## ANN ARBOR HISTORIC DISTRICT COMMISSION

### Staff Report

**ADDRESS:** 514 S First Street, Application Number HDC22-1095

**APPLICATION:** The applicant seeks HDC approval to install a small garden shed behind the home near the back left corner of the property. The footprint of the cedar shed measures 70 inches wide and 75 inches deep and is 8 feet 4 inches at its roof peak. Existing 6-foot cedar fence along the left side and rear of the property, plus the home itself and garden plantings, will screen the shed from sidewalk views and adjacent properties.

**Plot Plan:**

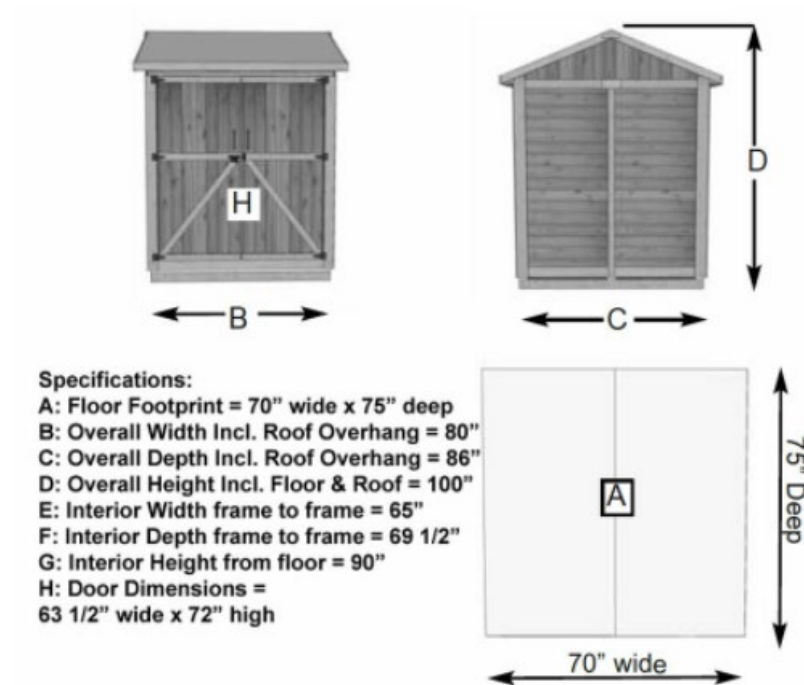
1. The approximately 6-foot by 6-foot cedar shed is modest in size, well screened from

view anywhere off the property, and appropriate for the property and district. Its material and design are compatible and complimentary.
